PLANNING AND ZONING BOARD STAFF REPORT

Harbour's Edge

Meeting	File No.	Application Type
February 26, 2024	2023-226	Level 3 Site Plan
Property Owner		Agent
Lifespace Communities, Inc.		Yoan Machado, WGI, Inc.

Consideration of a Level 3 Site Plan, Landscape Plan, and Architectural Elevations for the construction of a 40 bed, three-story, assisted living and memory care facility at the existing Harbour's Edge continuing care retirement community, located at 401 East Linton Boulevard.

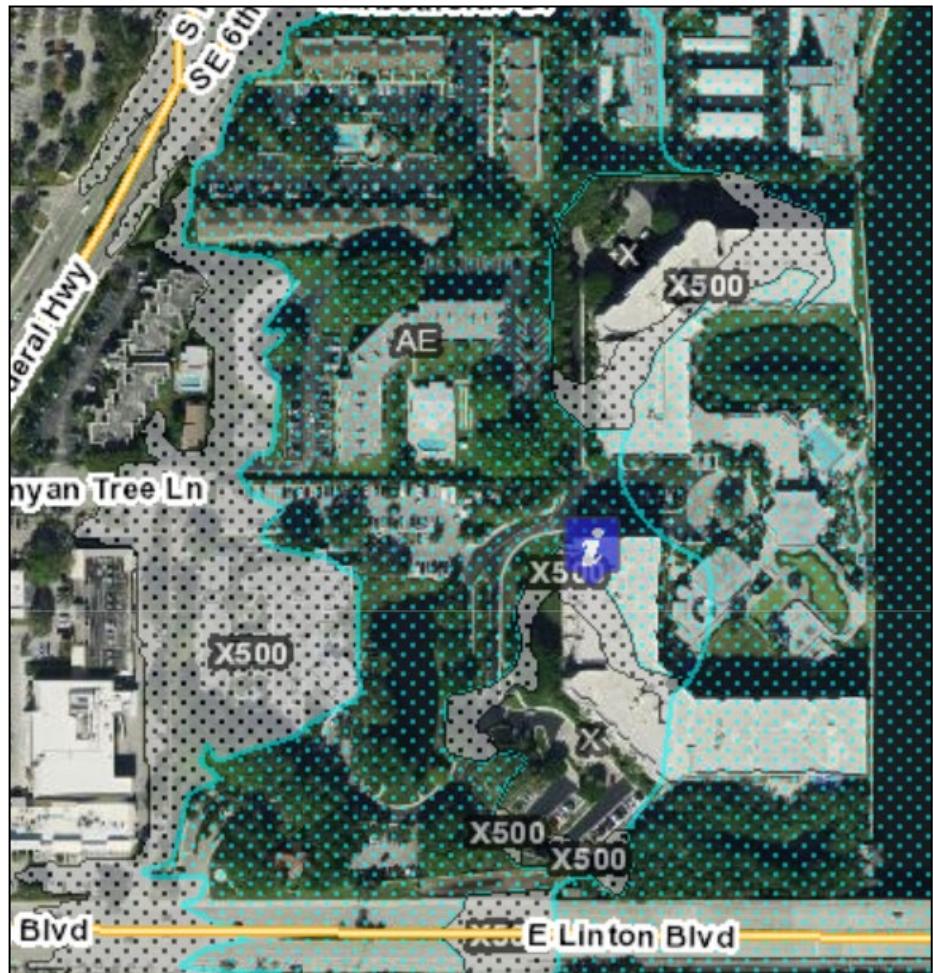
The subject property is located in a Flood Zone (AE6) within the Coastal High Hazard Area (map at right); the next official Flood Zone map update is updating the Flood Zone from AE6 to AE7. Flood Zone AE7 requires new construction to be built at a base elevation one foot higher than Flood Zone AE6. The proposed site plan is designed for the pending Flood Zone AE7 requirements, pursuant to the requirements in **LDR Section 3.2.4(D), Flood Prone Areas**.

A key aspect of the analysis revolves around the question of whether the proposed building is considered an increase in density, and therefore not allowed within the Coastal High Hazard Area. Pursuant to Table NDC-1 of the Comprehensive Plan, MD land use only has a density standard (based on dwelling unit count), not Floor Area Ratio (FAR), which measures intensity. A Dwelling Unit is defined as *“One or more rooms connected together, designed to be occupied by one family, constituting a separate, independent housekeeping establishment and physically separated from any other dwelling unit which may be in the same structure, and which contains independent sanitation, living, cooking and sleeping facilities”* (**LDR Appendix A, Definitions**). The 40 proposed memory care and assisted living beds do not have the components of a dwelling unit, and do not, therefore, qualify as dwelling units. Consequently, approval of the proposed development would not contravene the policies that discourage increased net density in the Coastal High Hazard Area.

According to Comprehensive Plan Policy CME 4.1.2, within the Coastal High Hazard area, the City should *maintain a coastal high hazard evacuation time of 7-10 hours and reduce hurricane clearance times within the city* in support of regional evacuation efforts. The application narrative discusses two neighboring retirement communities operated by Lifespace west of I-95 in Delray Beach, which the applicant states have the capacity to accommodate any residents evacuated from the subject property in case of an emergency. However, the evacuation plans for the municipalities are maintained with Palm Beach County, not the City. **Therefore, the applicant must notify Palm Beach County of the changes to include the proposed 40 beds.** It has been added as a technical note that **the applicant must provide proof of submittal to Palm Beach County Emergency services prior to issuance of a Certificate of Occupancy.**

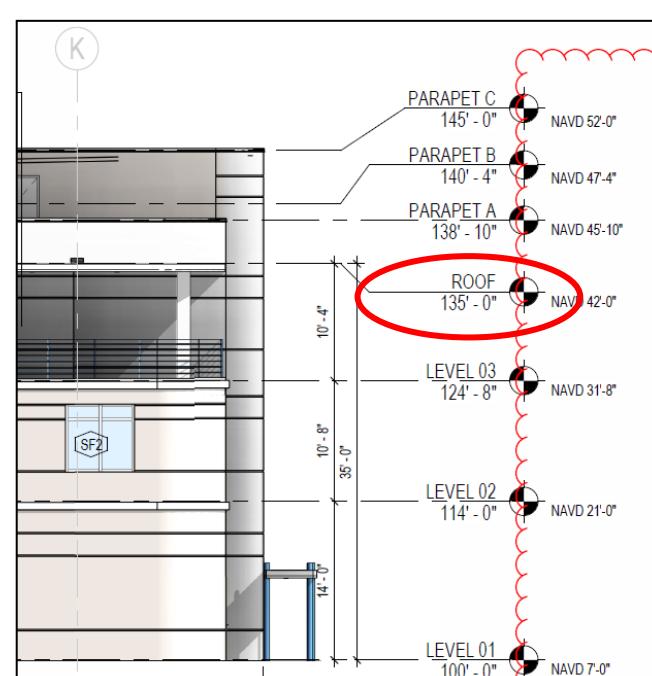
LDR Section 3.2.4, Standards for Specific Areas or Purposes. Subsection (D), Flood prone areas requires that *development proposed on land which is in a floodplain shall certify that the proper requirements for mitigation of potential flood damage have been provided.*

Currently, the continuing care retirement community campus falls within the AE6 flood zone, and upon the implementation of the new FEMA maps, it will be reclassified as AE7 which will increase the Base Floor Elevation by one foot. As discussed above, the proposed site plan complies with the AE7 classification.

Landscape Plan

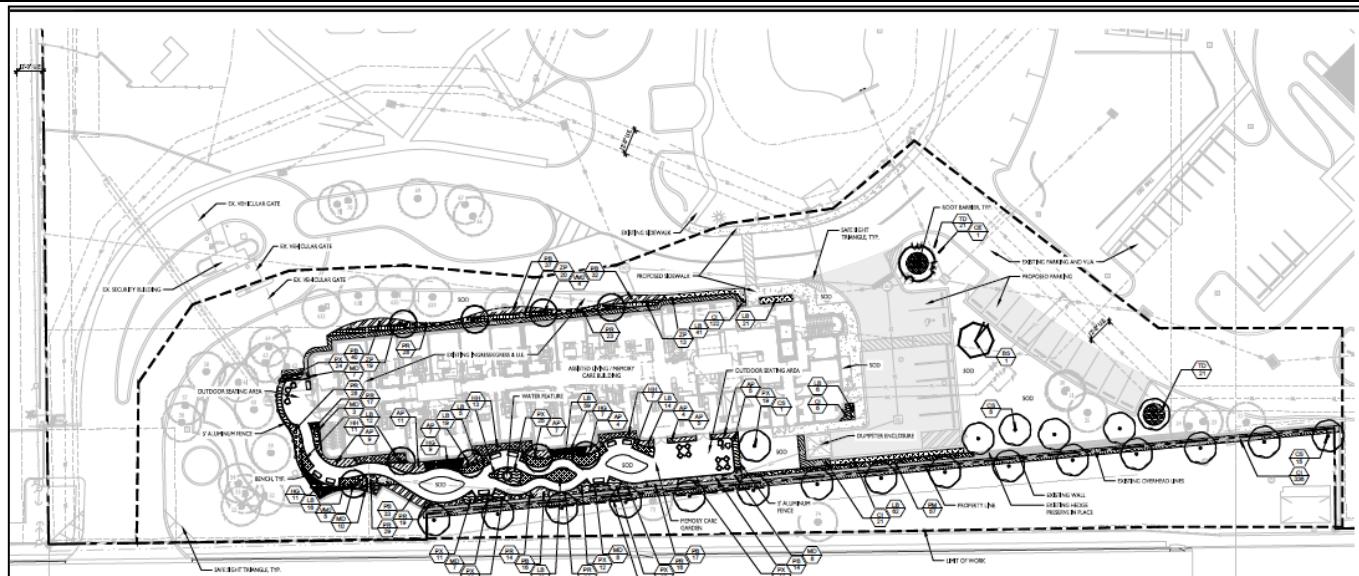
The landscape plan has been deemed technically compliant pursuant to the applicable requirements of LDR Section 4.6.16. The project includes new landscaping surrounding the proposed building and sports court. Silver Button Wood trees are provided adjacent to Linton Boulevard and provide shade to the residents. A memory garden located on the south side of the building adjacent to Linton Boulevard is provided for the residents and include benches and a water feature. Pygmy Date Palm and Yew Pine are provided along the eastside adjacent to the Intracoastal Waterway. Shrub areas include Red Ginger, Cocoplum, Heliconia, Phildendran, and Fakahatchee Ground cover is provided with St. Augustine Grass and Big Blue Lilityturf. Below, is the Landscape Plan outlining the placement of the proposed trees, shrub areas, and memory garden.

There are 32 trees identified for removal, which include a mix of invasive species, palms, and shade trees. An in lieu fee of \$147,975 must be paid into the Tree Trust Fund prior to issuance of a building permit.
